# F.P.E. 596 CULMINATING PROJECT: WARREN J. BAKER CENTER FOR SCIENCE BUILDING REVIEW

## SPRING 2017

This report is a focused review and discussion of the life safety and fire protection design of Cal Poly Building 180: The Warren J. Baker Center for Science in partial fulfillment for the requirements of a Master's of Science degree in Fire Protection Engineering at Cal Poly, San Luis Obispo. The report focuses on discussion areas specific to the curriculum of the Cal Poly Fire Protection Master's program, including analysis of egress, structural fire protection, detection, alarm and automatic protection designs in comparison to current and effective codes and standards. This report also includes a, performance based, tenability analysis for the central atrium and the building egress using computer-modeling software (FDS, PyroSim and Pathfinder)

Figure 31 - Visibility at 390 seconds

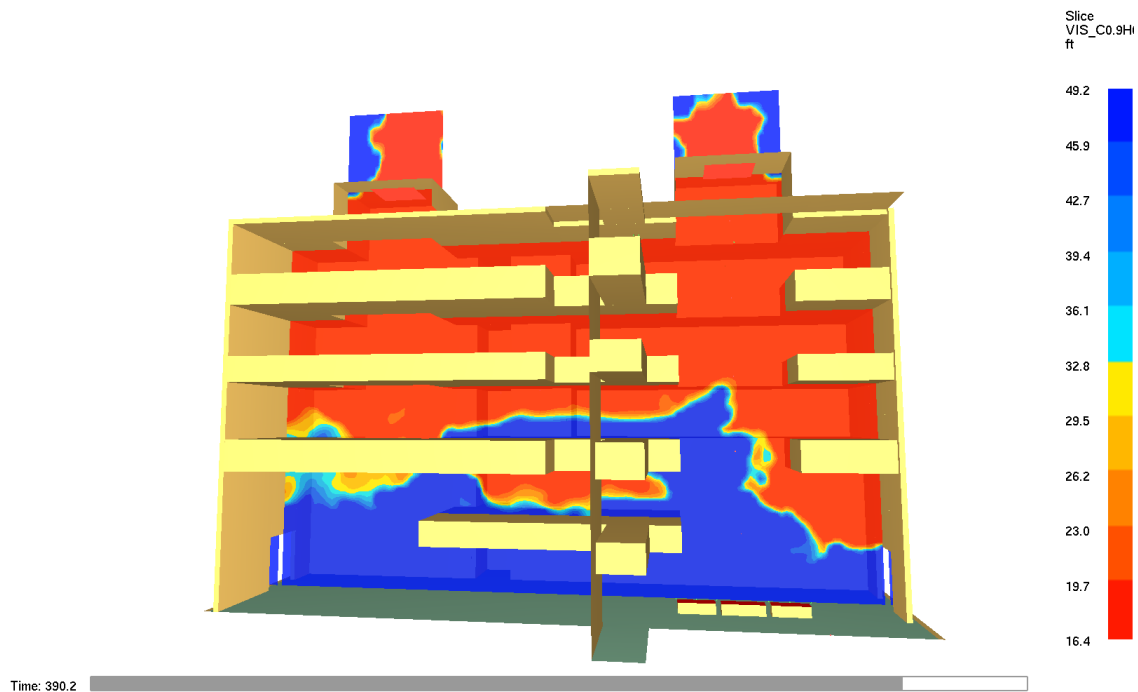
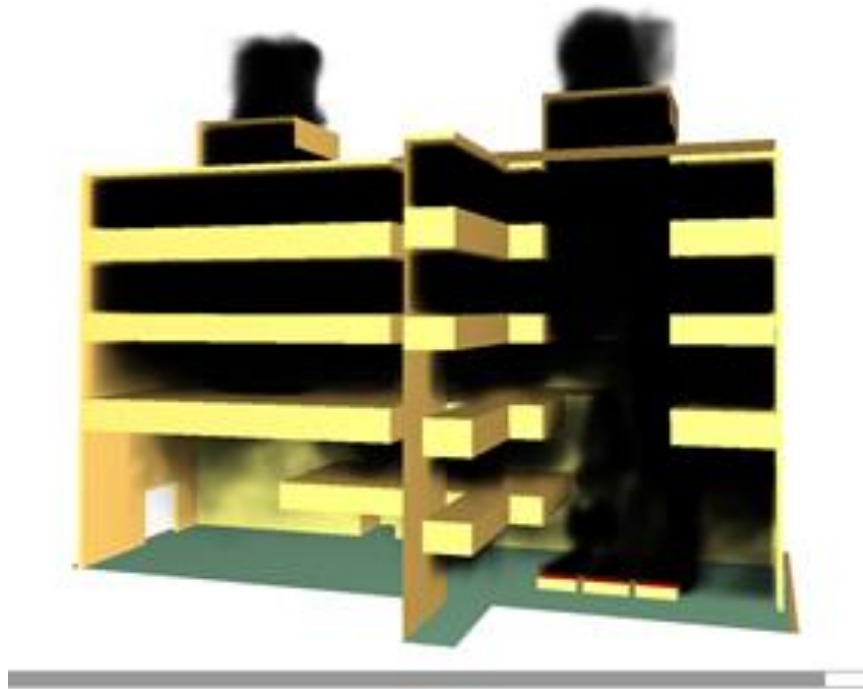
Looking at the visibility and smoke visualization at 390 seconds (time needed for evacuation of the 6<sup>th</sup> level), the occupants of the 6<sup>th</sup> level will be subjected to smoke for a prolonged period. The FED method discussed in the tenability section has been applied for the area adjacent stair #3. Table 16 tabulates the total FED for the 12-minute exposure, and Figure 32 indicates the expected gas levels.

To provide tenability for the central atrium, a mechanical exhaust system is recommended to provide adequate visibility, 6ft. feet above the egress paths. Additionally, less combustible, or noncombustible furnishing should be used to ensure that acceptable levels of heat flux are maintained for the duration of egress. The use of non-combustible or less combustible furnishing could also help to maintain acceptable levels of visibility utilizing the existing smoke control system. Modeling should be completed to determine the most effective and economical approach.

**Figure 37 - Incident Heat Flux in Exit Stair #3 Hallway - 561.6s**

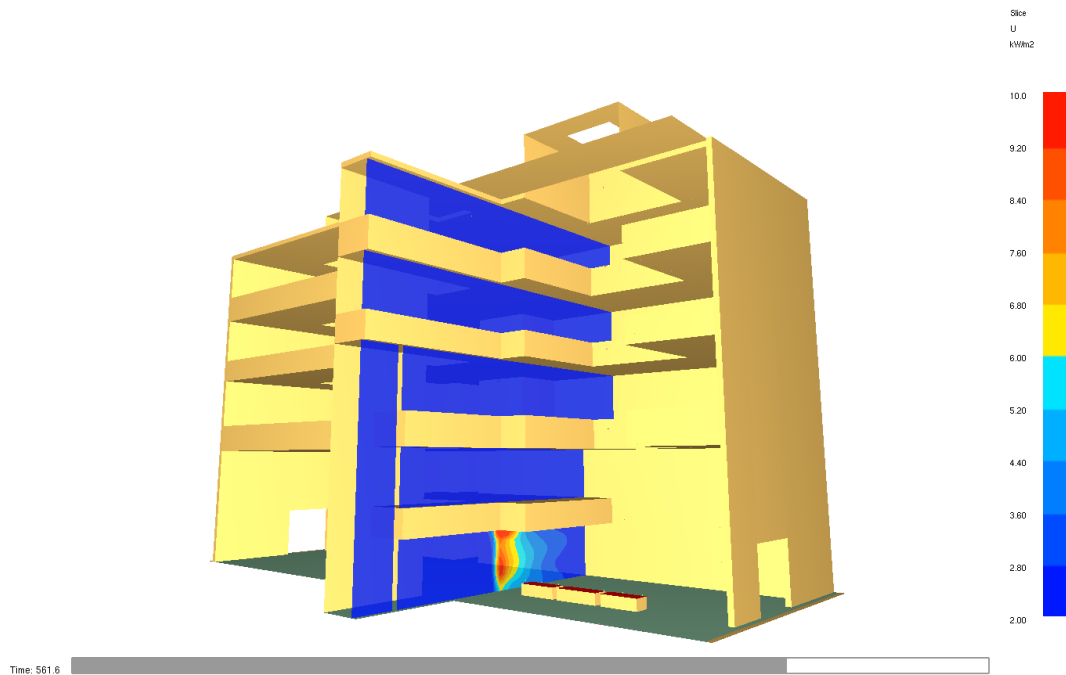
A heat flux of  $2.5 \text{ kW/m}^2$  was recorded in the vertical plane of the hallway from Exit Stair #3 at 180 seconds and peaks to over  $10 \text{ kW/m}^2$  around 562 seconds. Figure 37 illustrates the predicted heat flux at 561.6 seconds. Since occupants are expected to utilize this area as a means of egress for the duration of the evacuation, this model is also expected to fail due to high levels of heat flux in addition to loss of visibility.

FDS indicated that our model, and passive smoke control system, is not expected to provide tenable conditions after 101 seconds (1.7 minutes), due to loss of visibility. The model also indicated that even if additional ventilation is provided, tenable conditions still may not be possible due to excessive heat flux in the area adjacent the exit of Exit Stair #3. With the current building design, tenability limits for air temperature, and smoke toxicity are expected to be maintained for the duration of egress. This FDS model indicates that the available safe egress time (ASET) for this building would be 1.7 minutes.

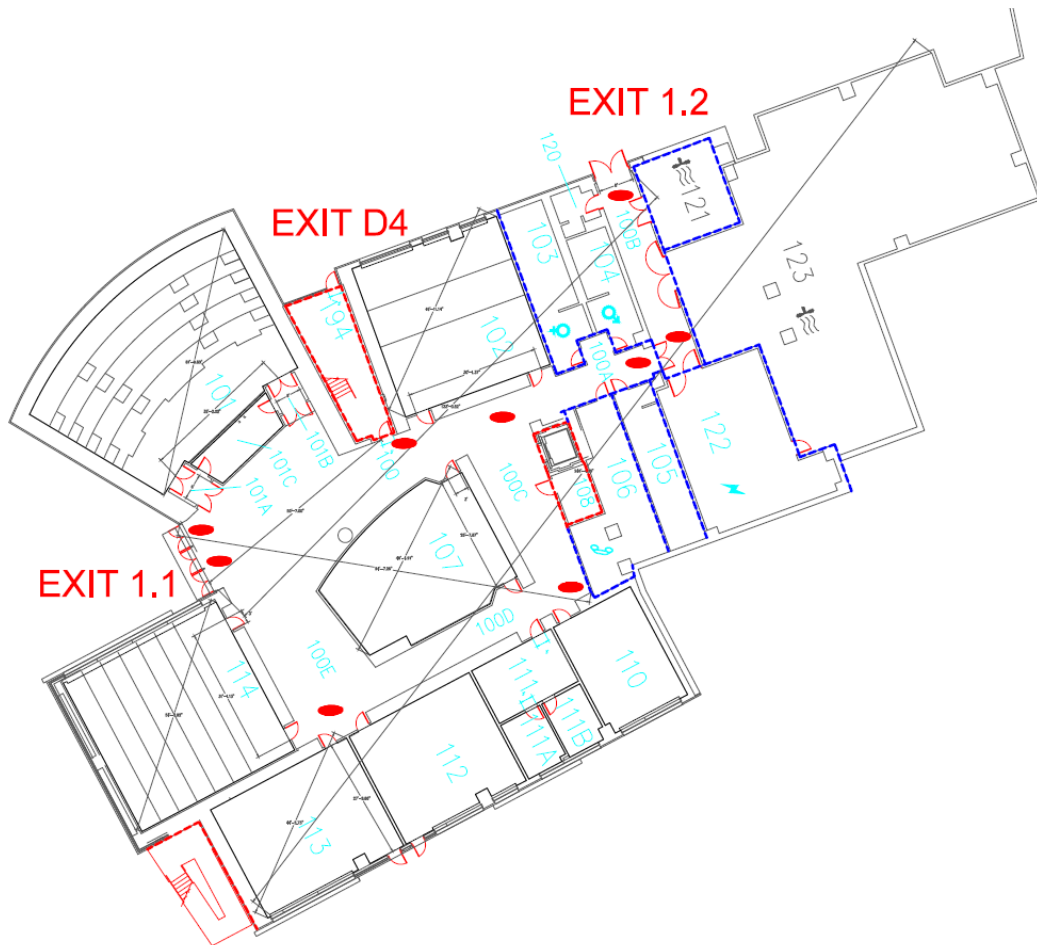
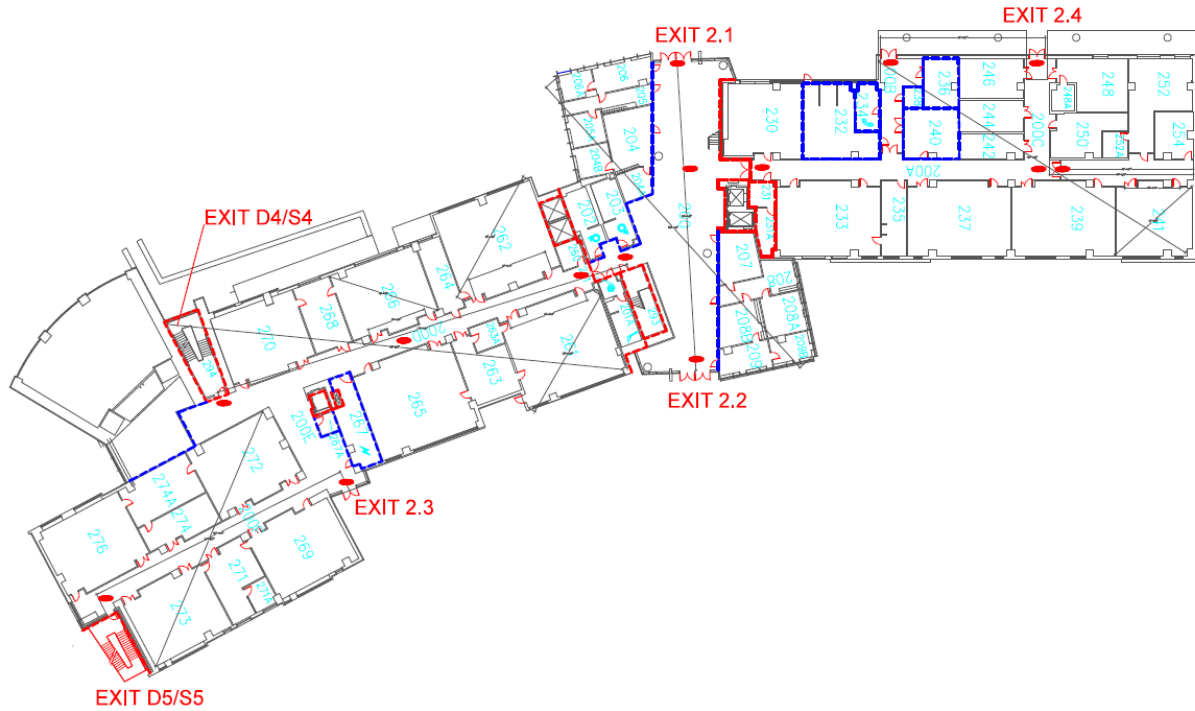
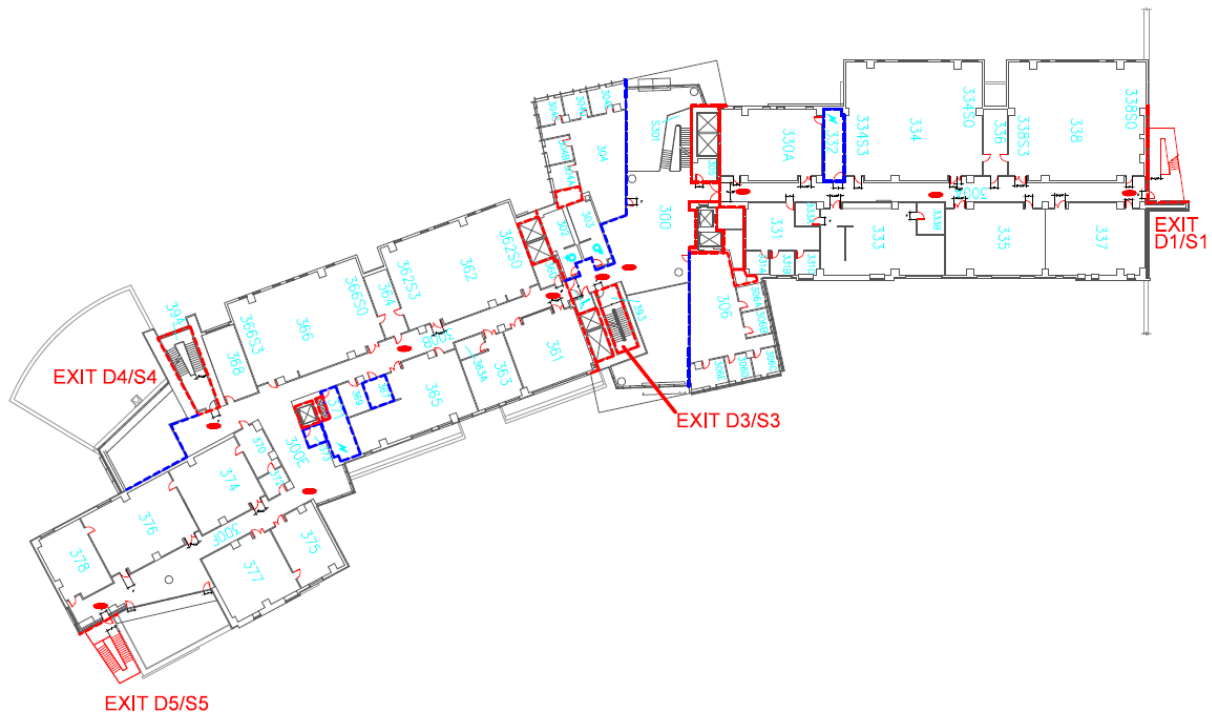
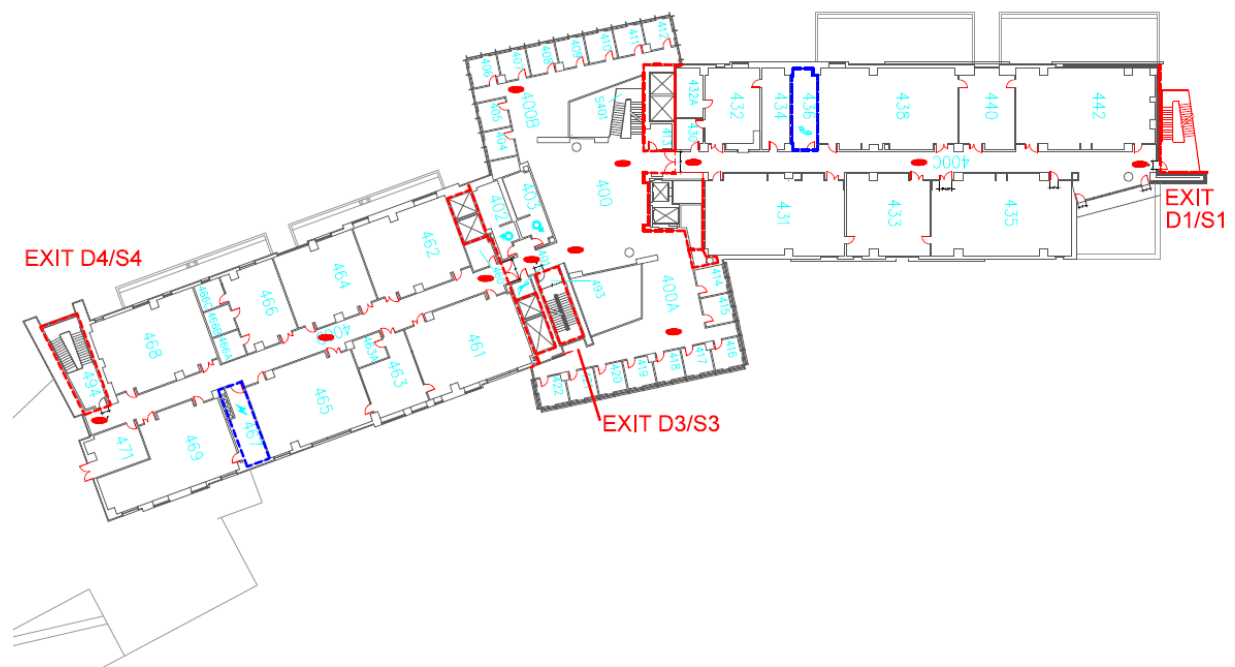
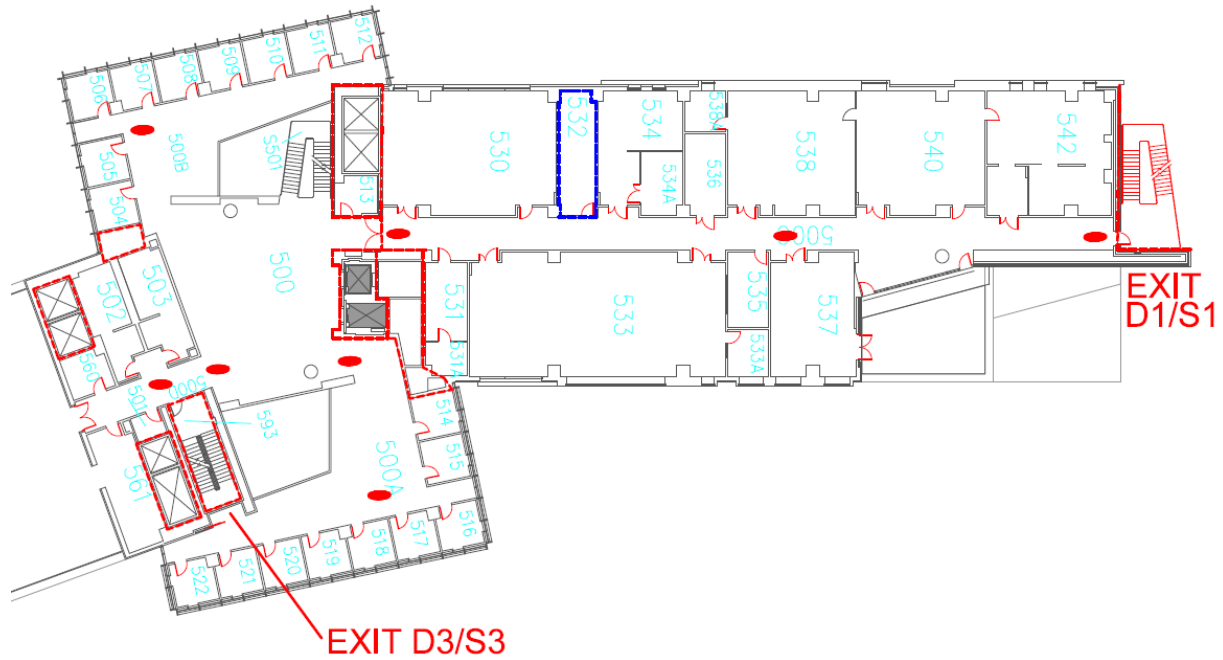
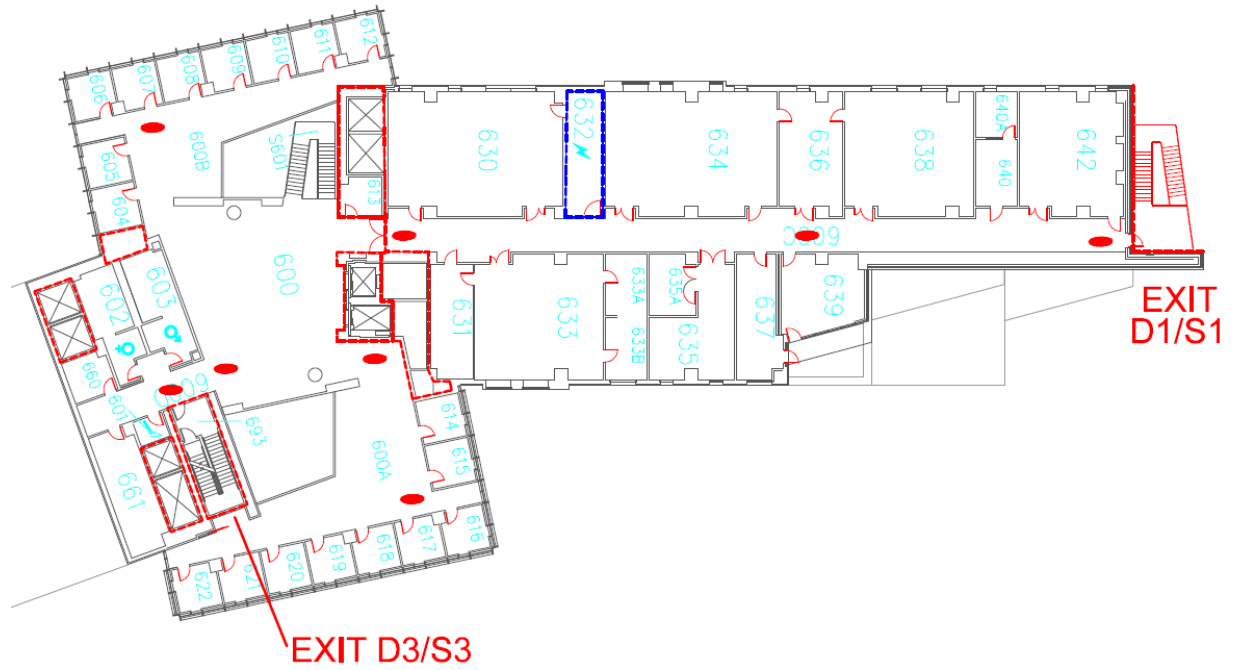
See Appendix A for the recommended exit sign locations. The exit signs are marked with a red elliptical symbol. Although not indicated, to reduce clutter in the drawing, exit signs should be placed in every room above the exit door.
